Sl. No.	Tender Reference (Document name/Page no./Clause no./Clause name)	Pre-Bid Query raised by Bidder	CEG Response
1	4.15.15 -Drainage -2 Nos adequate size hole for water drainage	Location & size of Holes? Please specify	As degree of protection is of IP 55 protection class, so any opening may violet the degree of protection. No opening for drainage required.
2	5.2 Bus-Bar -- The Busbar's adaptor shall be mounted through two screws and further riveted at both the end	Not Clear, please elaborate or provide some sketches/ Photo/ Sample to understand	<p>This is about the fixing of busbar inside the JB. Min 2 screws/riveted/additional support shall be used or better mounting design can also be accepted. Below Pic is only for your kind reference.</p> <div><p>PIC 1</p><p>PIC 2</p></div>
3	5.2 Bus-Bar -- Anticorrosion compound shall be provided with each box for protecting bare aluminum conductor near contact area of terminal.	What type of compound? Please specify.	The anticorrosion compound of good quality with proven performance shall be provided over aluminium busbar

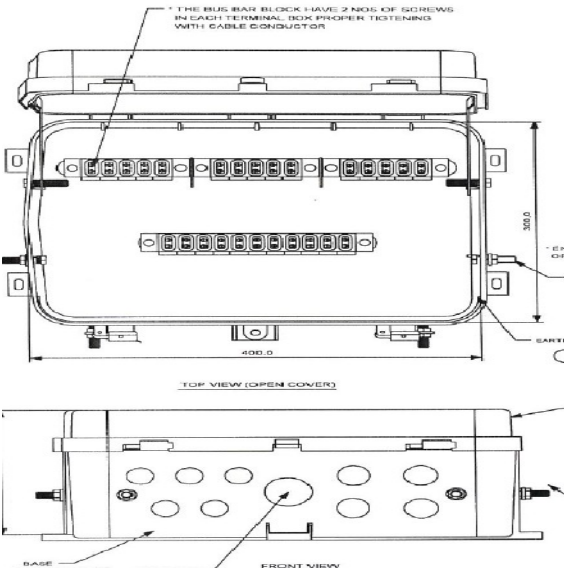
4	5.2 Bus-Bar -- Polycarbonate plastic material and mounted separately with the help of mounting lugs arrangement on DIN rail	Arrangement not clear, Please elaborate.	Horizontal Bus bar arrangement with 3 phases (RYB) at Top and neutral bus bar at the bottom with some elevation. For more clarity, please find the Pic attached for your kind referral only. Refer pic 2.
5	5.3 Sealing of Box -- The box shall be provided with a safety key made of PA 6.6 (Nylon)	Not clear to us, Please elaborate	The box shall be provided with a safety key made of PA (Polyamide) 6.6 (Nylon) to ensure theft proof locking arrangement. The Key shall be identical for all the boxes. PA 6.6 (Nylon) is one of the most popular engineering thermoplastics.
6	5.3 Sealing of Box -- The box locking screw should be made of stainless steel or plating finished steel	Not clear to us, Please elaborate	The Material used for screw shall be stainless steel.

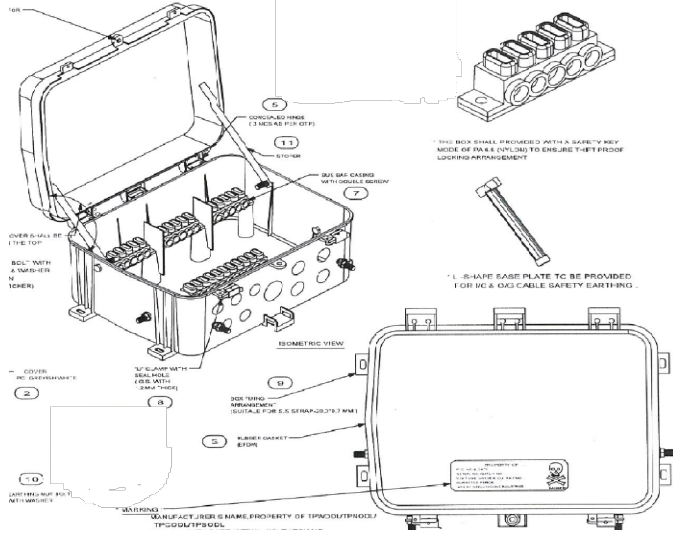
7	5.3 Sealing of Box -- The latch shall be GS with minimum thickness of 1.2mm	What is the meaning of GS here? Please specify.	The full form of GS is Galvanized steel.
8	5.5 Mounting Arrangement -- PSC/RSJ/HBeam/WPB poles by using Suitable Clamp/Cleat - 2 Nos	Clamp Size details required. Please specify	<p>As per TS, it shall be 50 X 6 mm or of suitable size with Nuts-and-Bolts arrangement (4 nos) or High strength Stainless Steel Strap with1+1 meter of 20mm x 0.7mm/suitable thickness. The arrangement shall be such that the strap runs behind the box and holds the box properly with pole.</p> <p>Out of two, one option will be decided during Detail Engineering</p>
